Addendum: **1**

Project: **FWCS Portage Middle School Restroom Renovations 2025**

## Addendum D1

re: **FORT WAYNE COMMUNITY SCHOOLS**  
**Portage Elementary School**  
**Restroom Renovation 2025**  
 MPG No. 111028.00

TITLE:  
**Finish & Equipment Plan, Schedules, and Finish Legend**

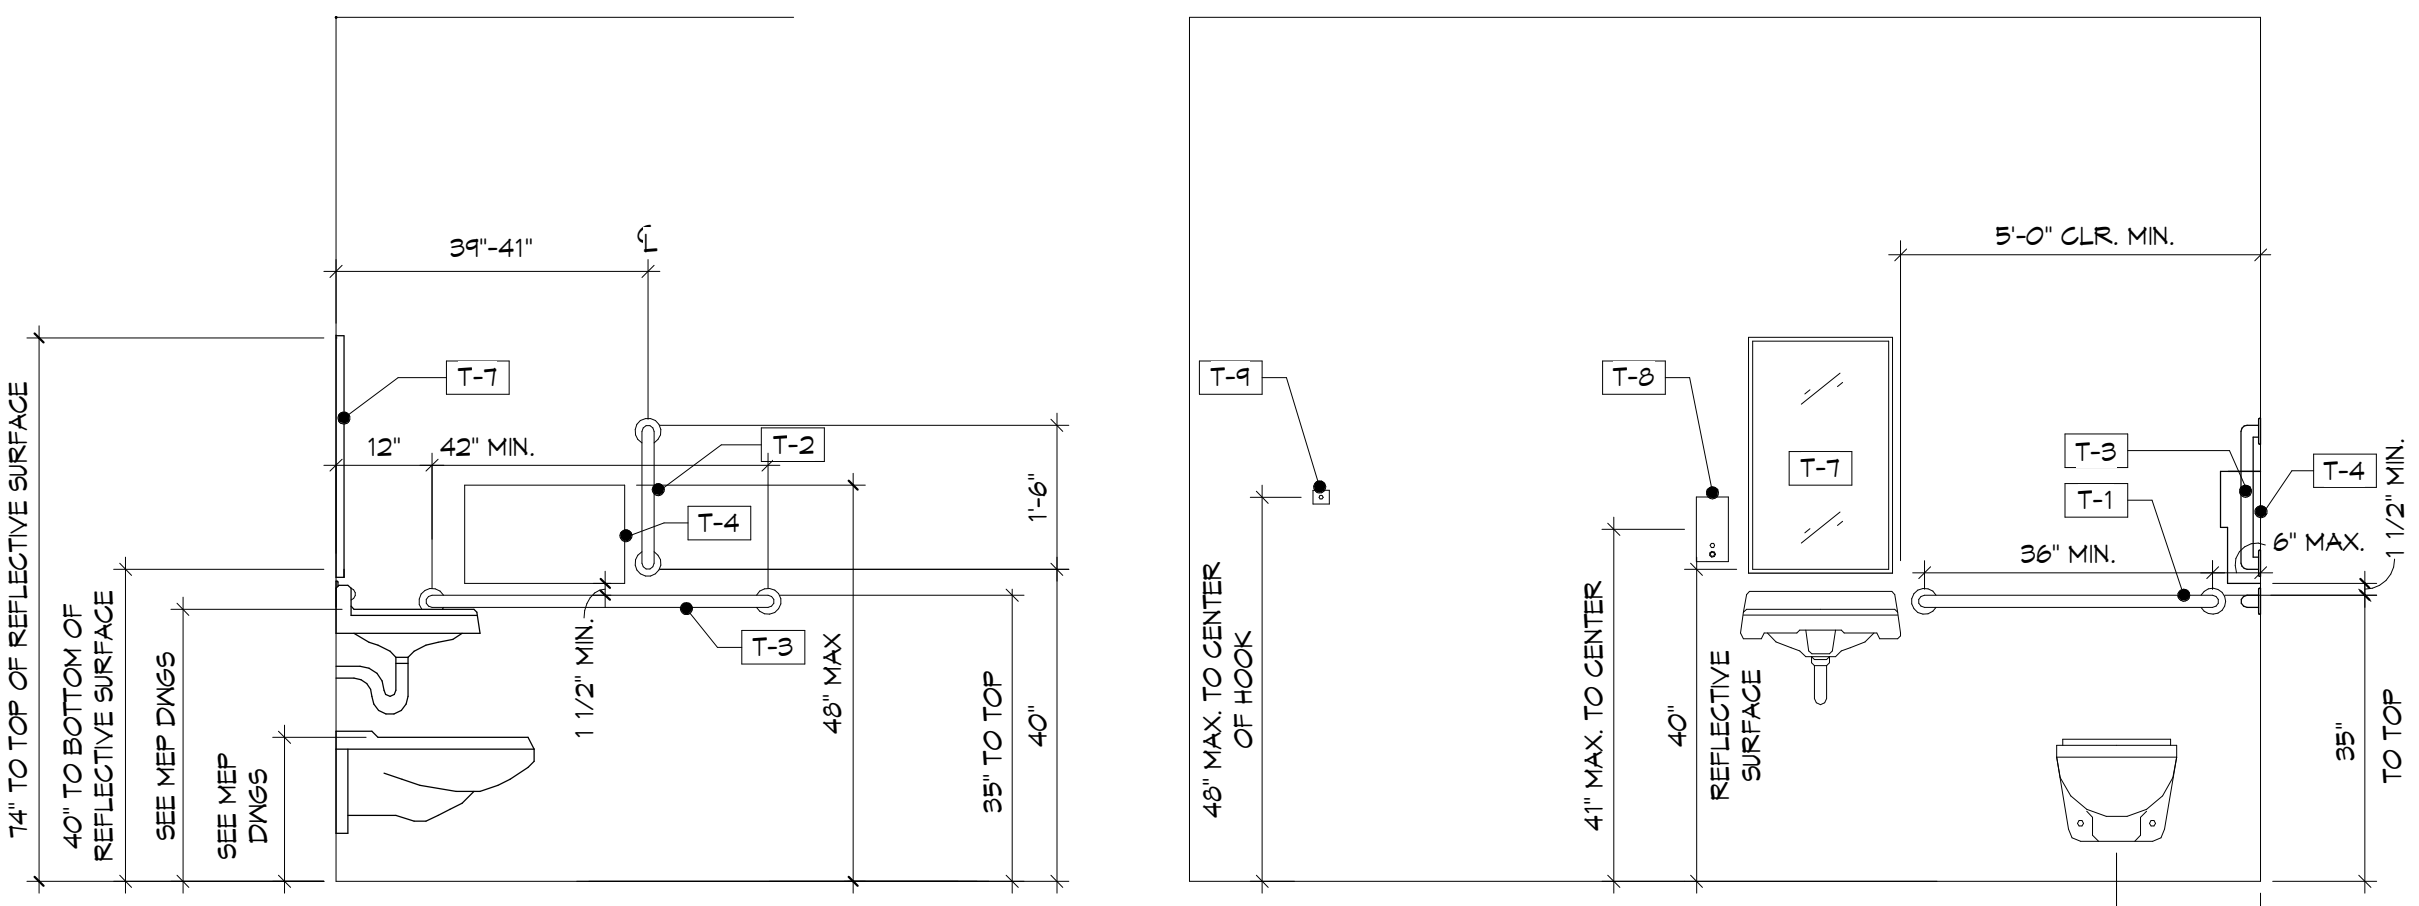
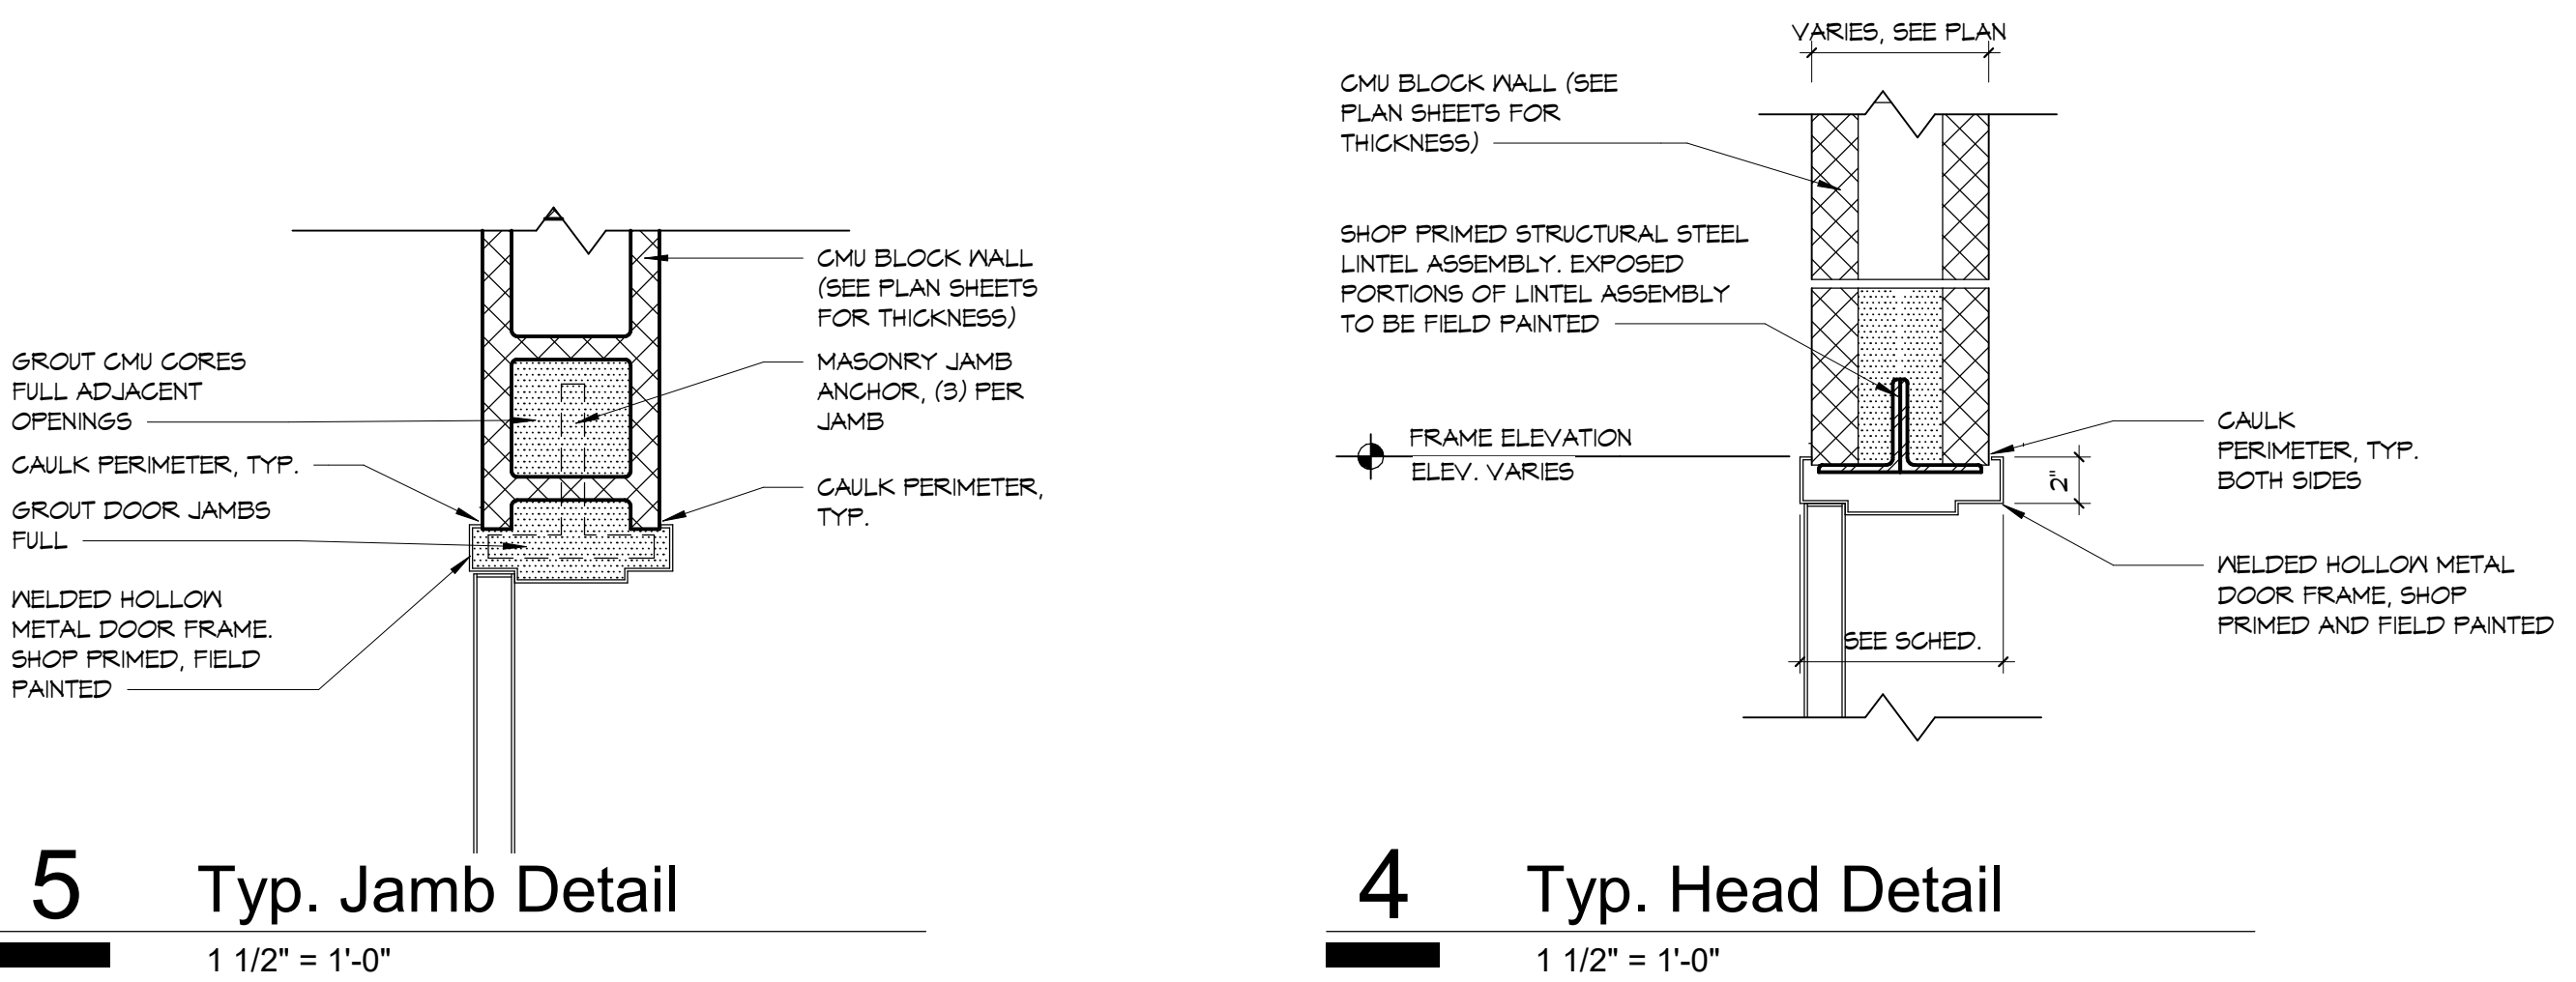
ITEM	LOCATION	DESCRIPTION
A1.01	SPECIFICATION Section 087100 Door Hardware <b>(New Specification)</b>	<b><u>ADD:</u></b>  ADD new specification Section 087100 – Door Hardware dated January 17, 2025, issued as part of this addendum as an integral part of the project Construction Documents.
A1.02	DRAWING A2.0 <b>(Drawing Reissued)</b>	<b><u>ADD:</u></b>  Reissue attached Sheet A2.0 First & Second Floor Demo, Floor, & Reflected Ceiling Plan reissued for clarifications or additions to scope.
A1.03	DRAWING A7.0 <b>(Drawing Reissued)</b>	<b><u>ADD:</u></b>  Reissue attached Sheet A7.0 Finish & Equipment Plan, Schedules, and Finish Legend reissued for clarifications or additions to scope.
